More on the proposed desecration of Glen Etive

Notifications that two of the Glen Etive hydro applications had been withdrawn were issued by Highland Council last week but, before anyone celebrates, they have been replaced with new applications for the Allt Mheuran and the Allt Fhaolain. That re-starts the whole planning process. If you objected first time round, that objection is no longer valid. If you did not manage to comment then, now is your opportunity!

Fig. 2 Temporary access track to intakes during construction to be reinstated to allow ATV access afterwards on Bhiorean, Gaoirean, Charnan, Fhaolain and Ceitlein.

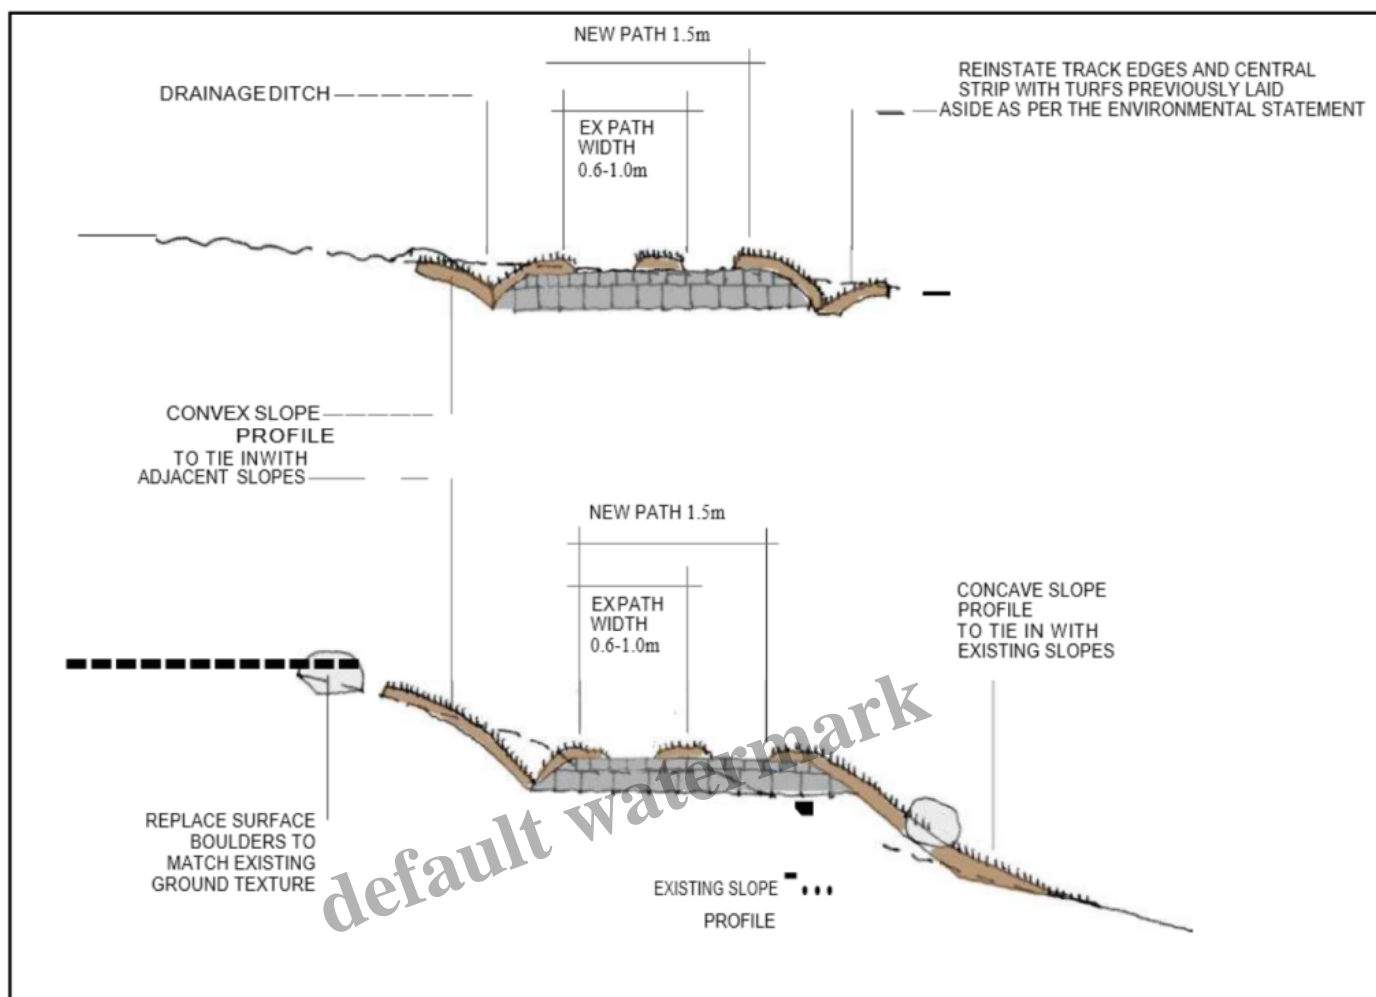
The text below the diagram appears to clarify that the proposal to narrow construction tracks to ATV width applies to five out of the seven schemes. While the Allt Mheuran tracks are now to be removed completely (see below) its not clear what is being proposed for the Allt Chaorunn where some new track was to be removed and some retained.

The diagram illustrates that Dickins Hydro is not actually proposing to restore the tracks – which would mean removing the imported material – but rather to cover them up. That will have a lasting impact on landscape and ecology. What is not explained.

Standard advice on track design recommends that if they are to avoid significant landscape impact they need to avoid cutting across slopes as illustrated.

Looking down Allt Mheuran, Beinn Trilleachan beyond, with approx position of former proposed permanent hydro track marked in red. Photo and photomontage copyright Tim Parkin (<http://www.timparkin.net>)

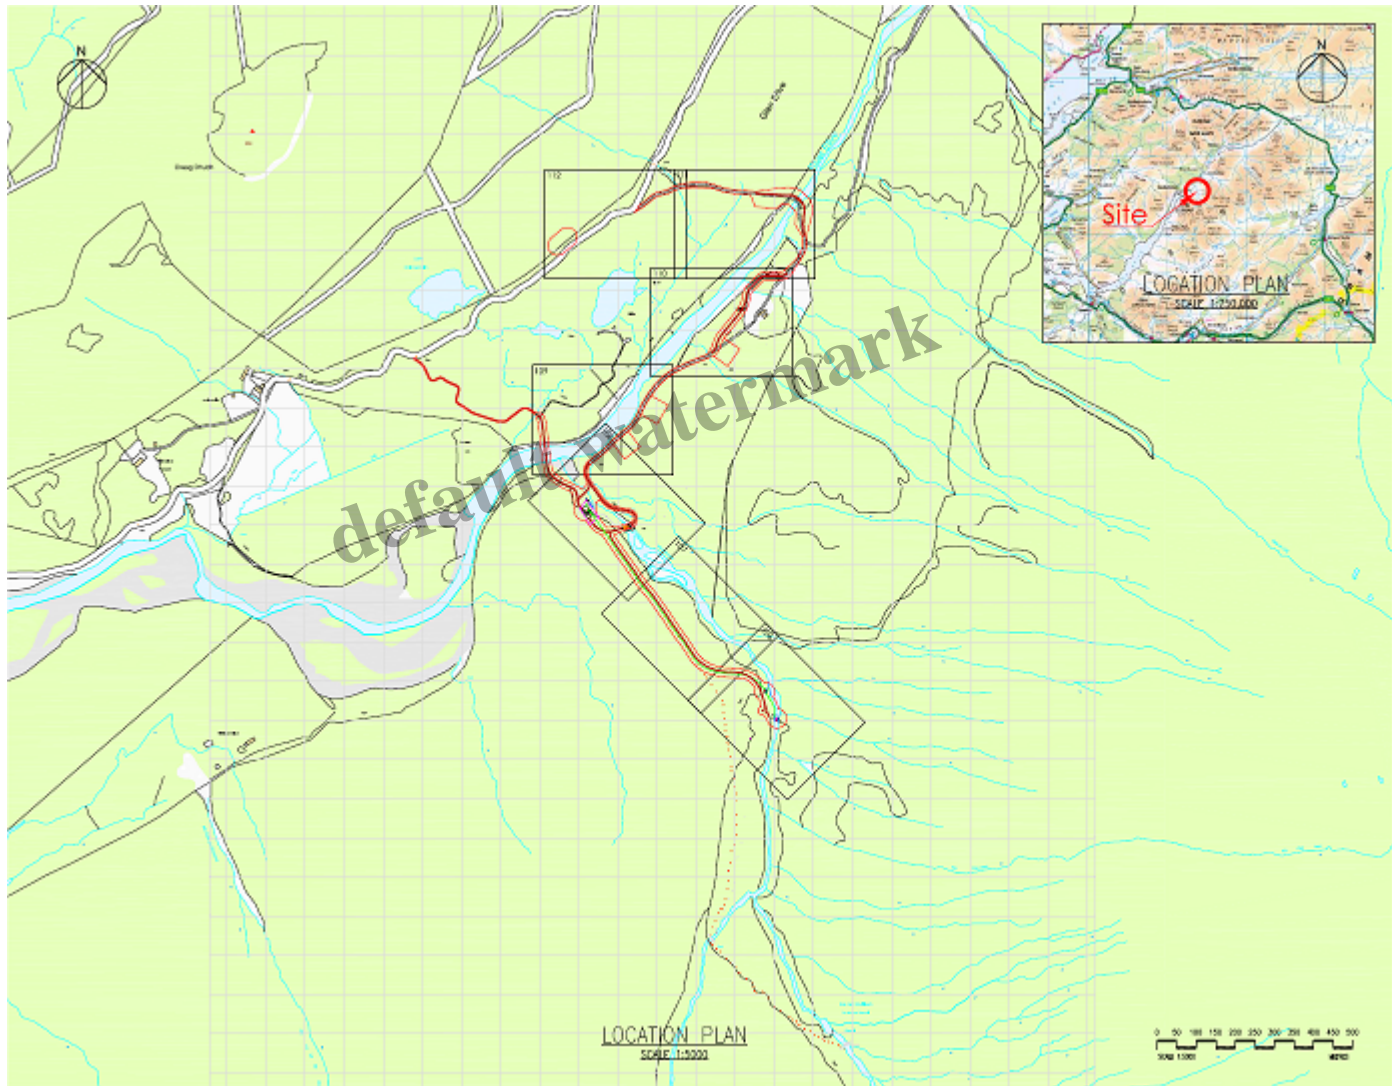
This sounds welcome in principle and will reduce the landscape impact significantly (photo above). It rather begs the question though if its feasible to lower the intakes and remove the tracks at the Allt Mheuran, why not apply the same thinking to the other Etive schemes too?

Revised location plan. It appears only the track above the powerhouse will be removed, leaving a new and “upgraded” tracks along the bottom of the glen.

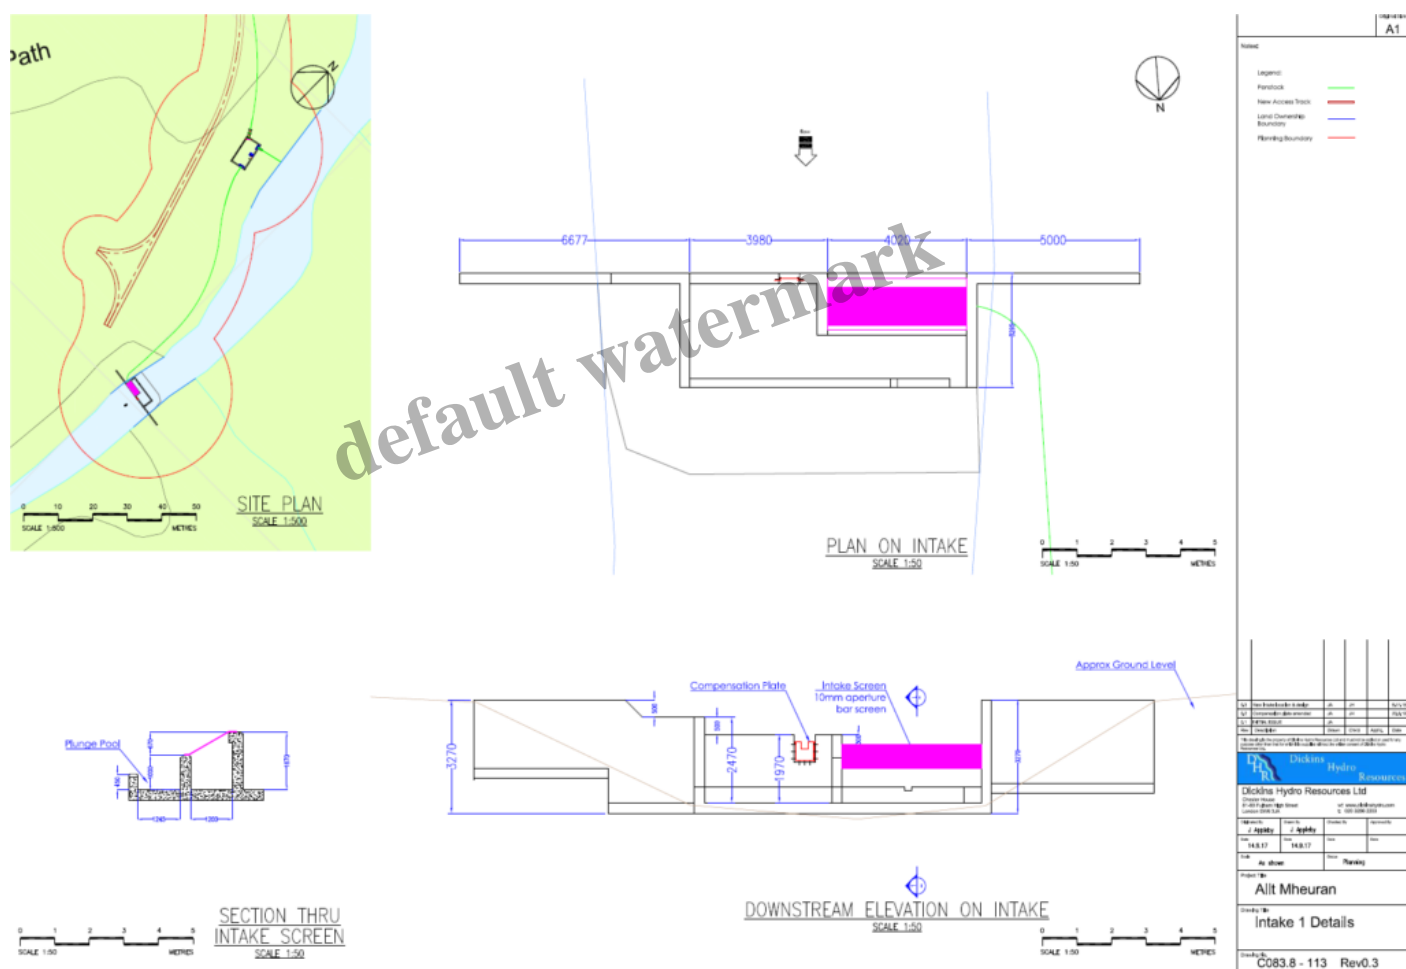
A new permanent access track to the Mheuran powerhouse, around the south side of Coileitir, is proposed. SEPA request a habitat survey for the new access track, however DHR Ltd submitted this report and habitat map with the original planning application. So not all new construction tracks are going to be restored after all? What is the specification for this new track? The Developer says this will be upgraded and realigned but gives no apparent consideration to the landscape impact.

- There is second section of new, and presumably permanent, access track which heads more directly across the River Etive (see plan above). Again, I cannot find any assessment of the landscape impact.
- The Zone of Theoretical Visibility Assessment has not been revised – it dates from December 2017 – despite the significant changes to the scheme

The Intake 1 details are still dated 2017.

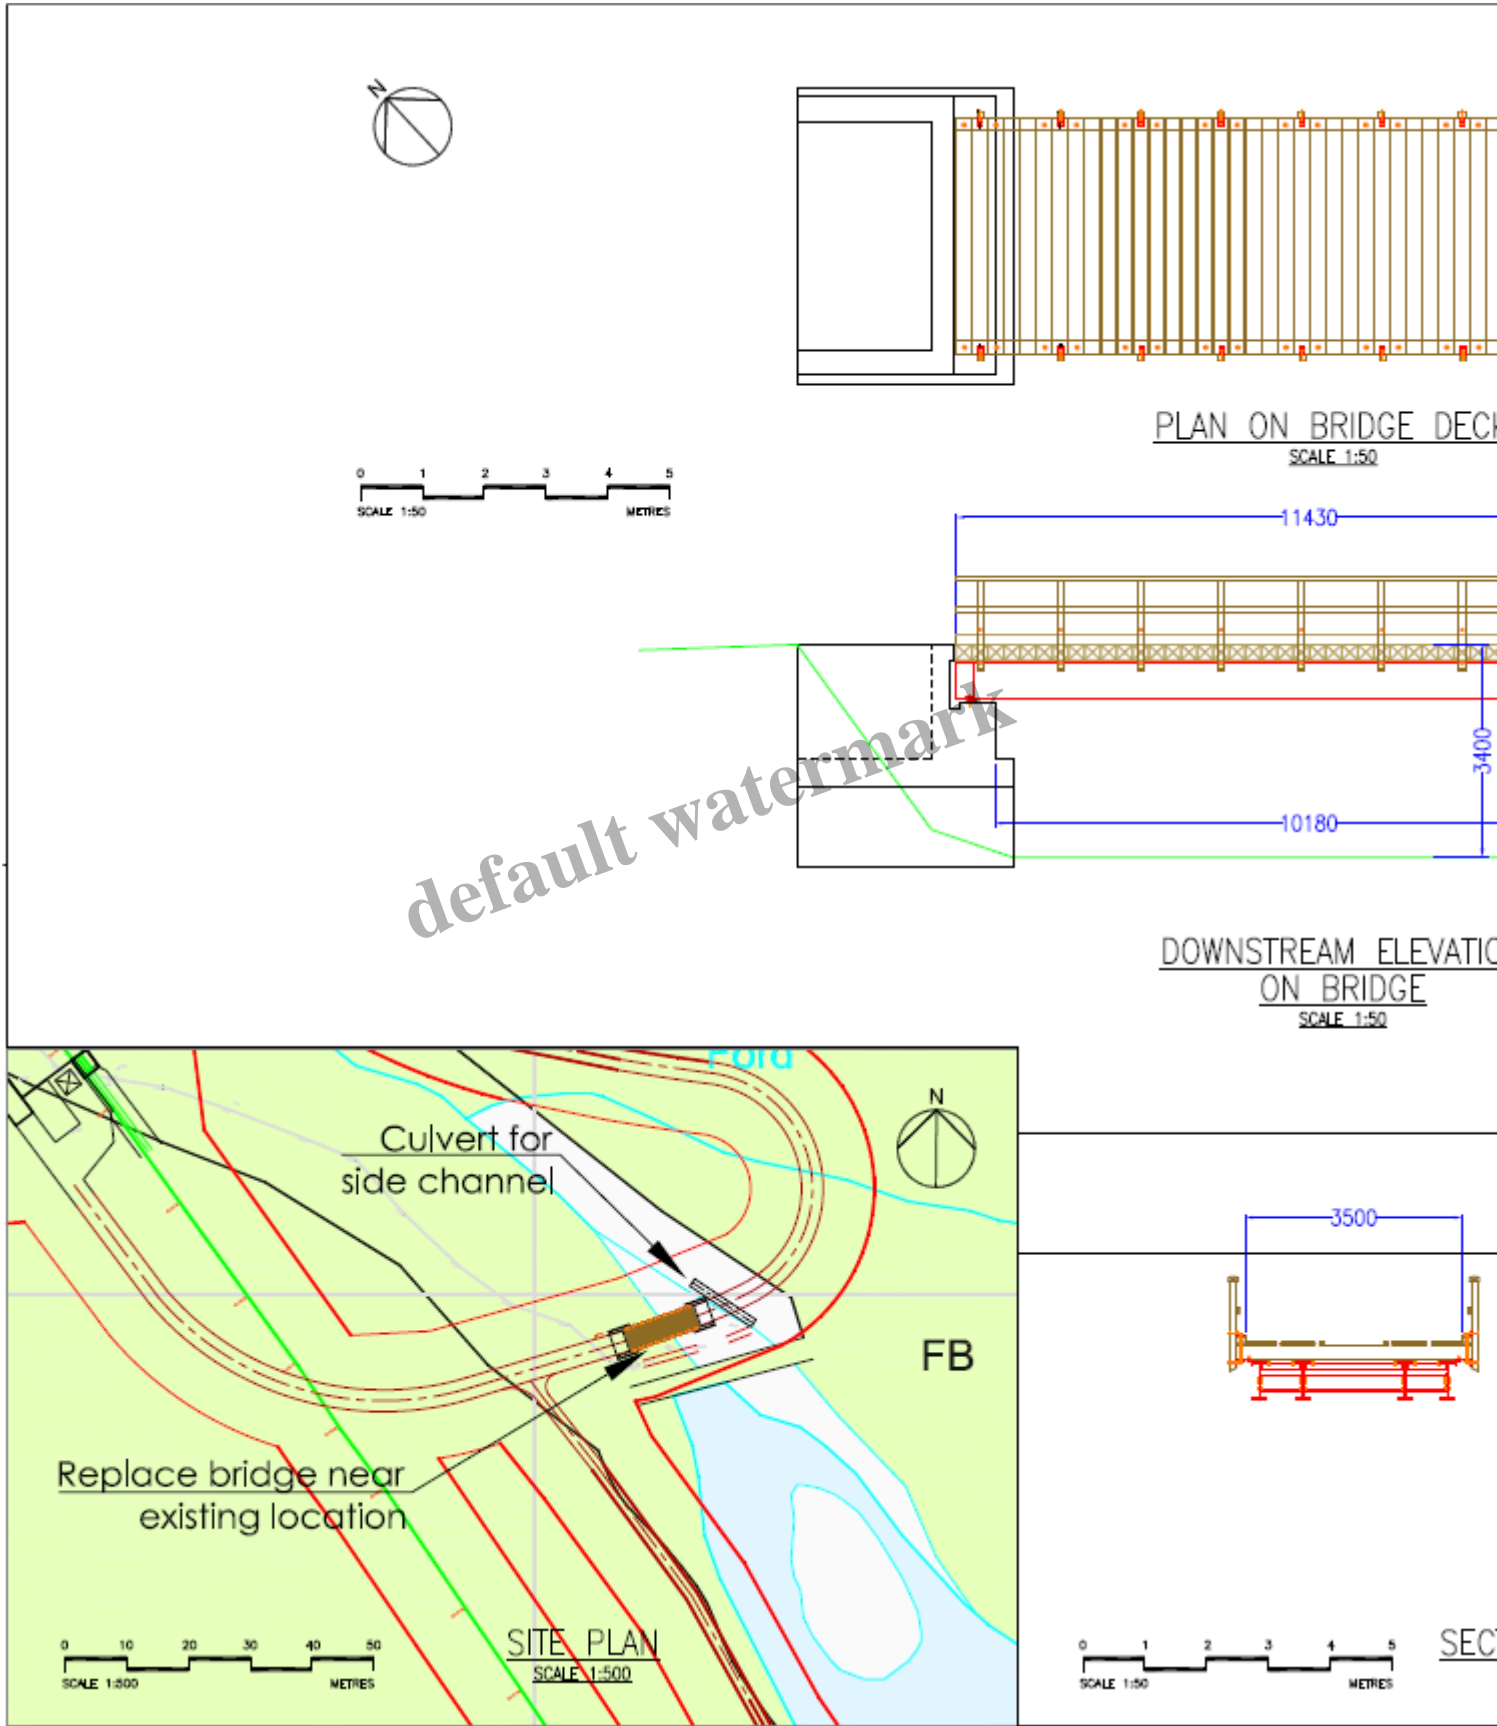
- While a new map has been added to the intake document dating from last year showing its location (along with what appears to be a permanent access track!) its unclear how the proposed design will fit in the proposed location, let alone how it will look. The size of any pool, the use of rip rap bouldering and whether the concrete walls will be faced in stone appear not to be considered.

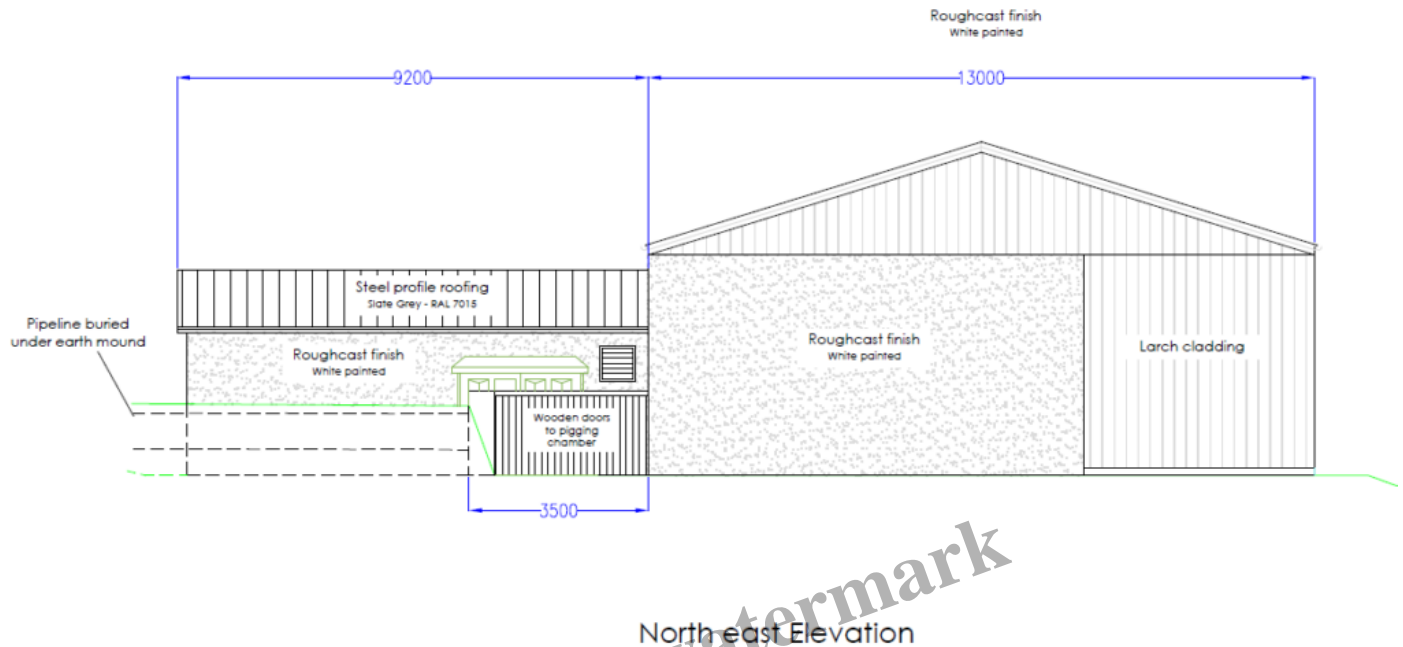
- Design details for the new bridge are also not supplied. The supporting pillars appear to be in concrete, totally out of keeping for Glen Etive

The previous Zones of Theoretical Visibility dating from Dec 2017 has been resubmitted – perhaps this is just a mistake?

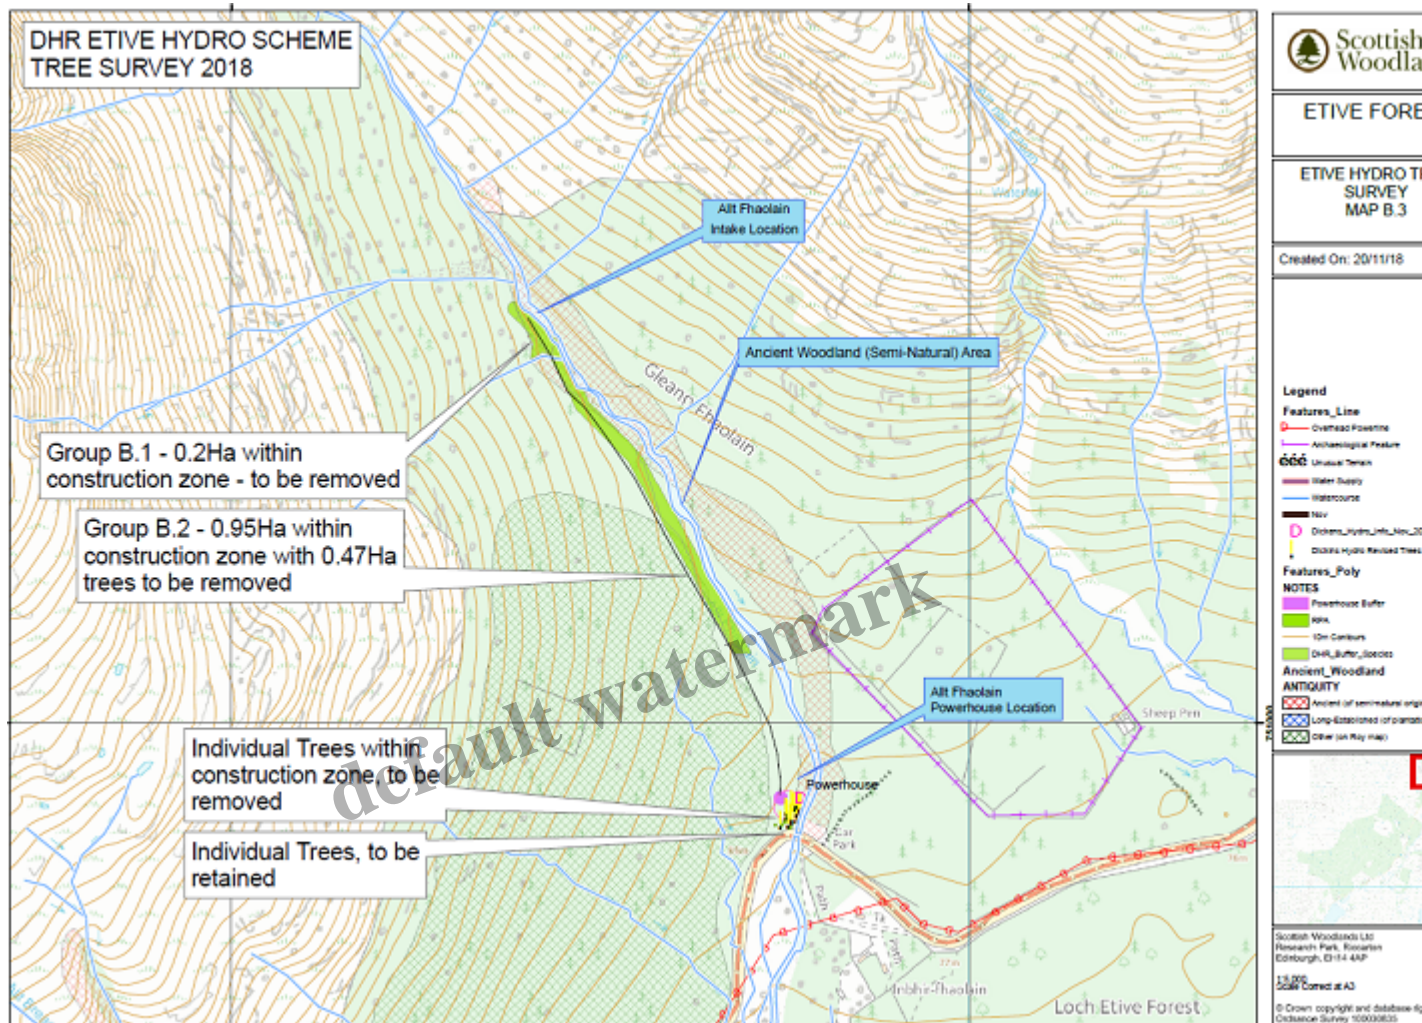
While the supporting documentation claims the Landscape Impact Assessment has been revised, the Assessment of Zones of Theoretical Visibility (Doc 5.6) still dates from December 2017 and still shows the powerhouse south of the road. While the powerhouse should now be less visible the assessment failed to include any consideration of the impact of the “upgraded” and new sections of access track on the landscape.

impact of tracks for the other Etive schemes the Developer appears to have felt under no obligation to provide this for the revised Allt Fhaolain scheme. That is NOT good enough and reason enough to object to this application.
